SANITARY SEWER ADJUSTMENTS TO SERVE A PORTION OF LOT 1, BLOCK 1 REGENCY PARK ADDITION CITY OF WICHITA, KANSAS

AS BUILT PLANS
CONTRACTOR: MIES CONSTRUCTION
SUPERINTENDENT: ALBERT WILLIAMS
FOREMAN: LANCE COWLEY
CLIENT: CITY OF WICHITA
INSPECTOR: ROSS POWERS
INSPECTION FIRM: SCHWAB-EATON, PA.
PDF BY: RJP 09/05/2023

GOODWILL
29TH & GREENWICH
WICHITA, KANSAS

SANITARY SEWER ADJUSTMENT
SANITARY PLAN & PROFILE

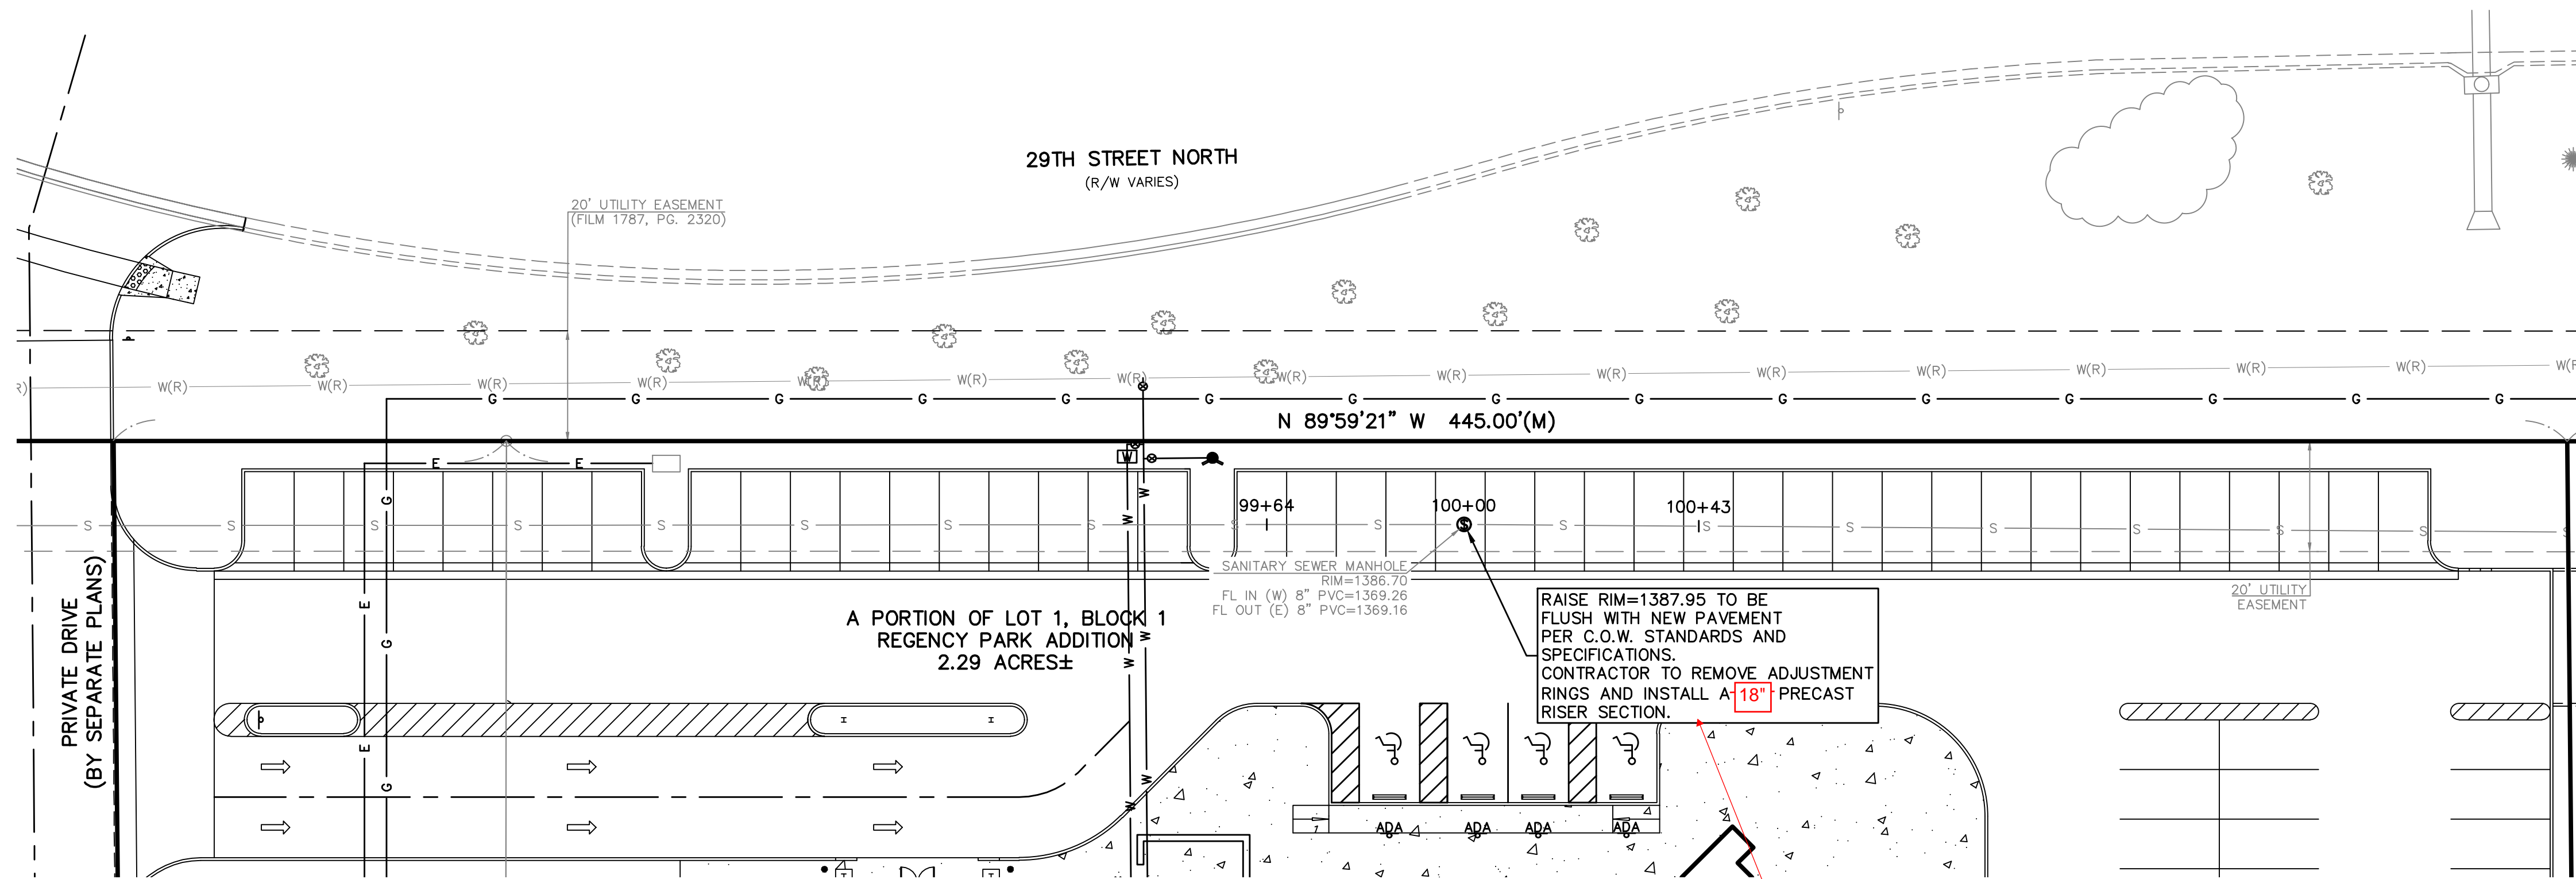
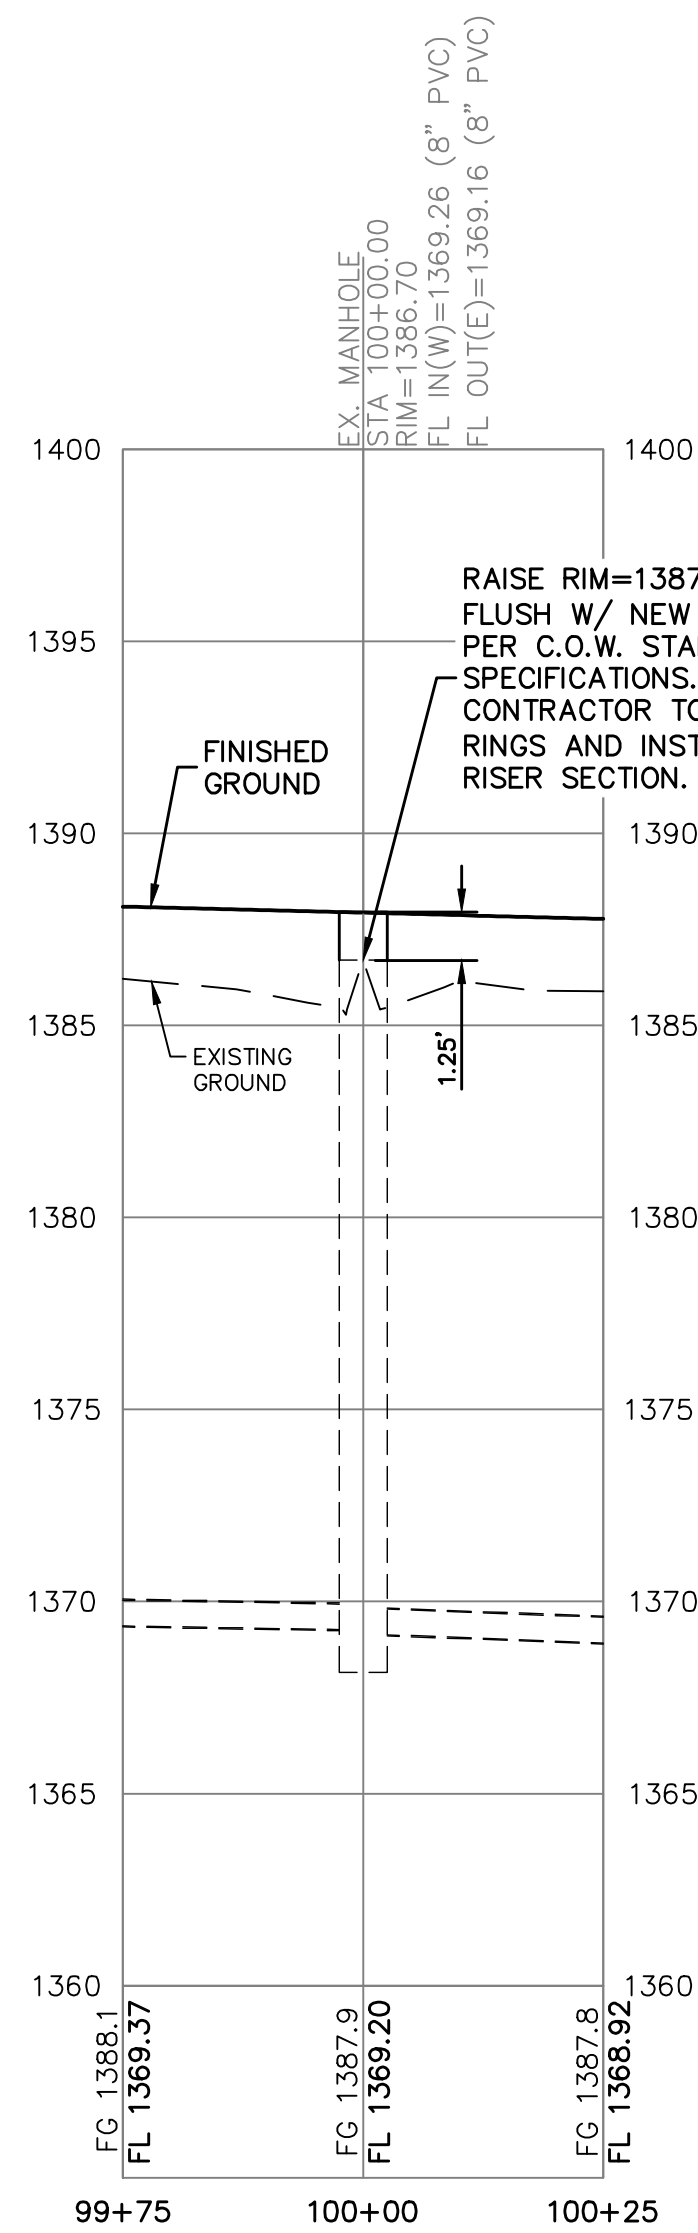
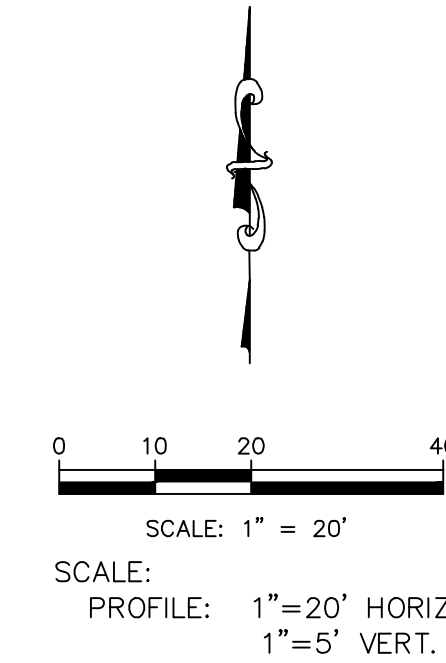
NEW RIM ELEV = 1387.93
CONTRACTOR ADD 18" RISER IN LIEU OF 24" AND SET RING AND LID TO GRADE PER PLAN

BUILT PER PLAN EXCEPT AS NOTED
